SERVICE BULLETIN

SUBJECT: COMMUNICATIONS – ACARS & CPDLC – Modify unit software and update TSAP database.

Figure 1. Label Marking

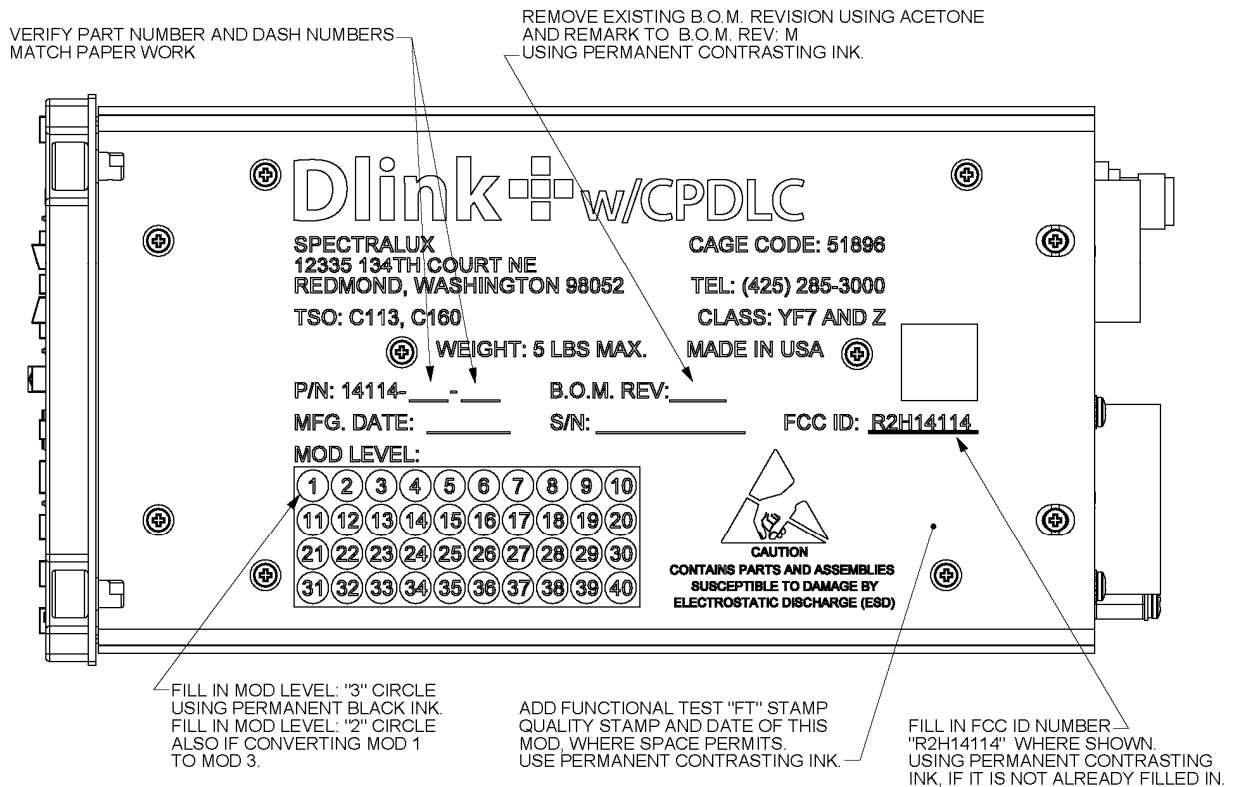
- (1) If all Conversion Results are PASS or NA , mark the unit label according to **Figure 1. Label Marking**.
- (2) Complete and archive automated test results (Spectralux Repair Station only) and Conversion Results worksheet from **5 WORKSHEET**.
- (3) Unit may be placed in service if all results on the Conversion Results worksheet are PASS, YES, or NA.
- (4) END Return to Service.
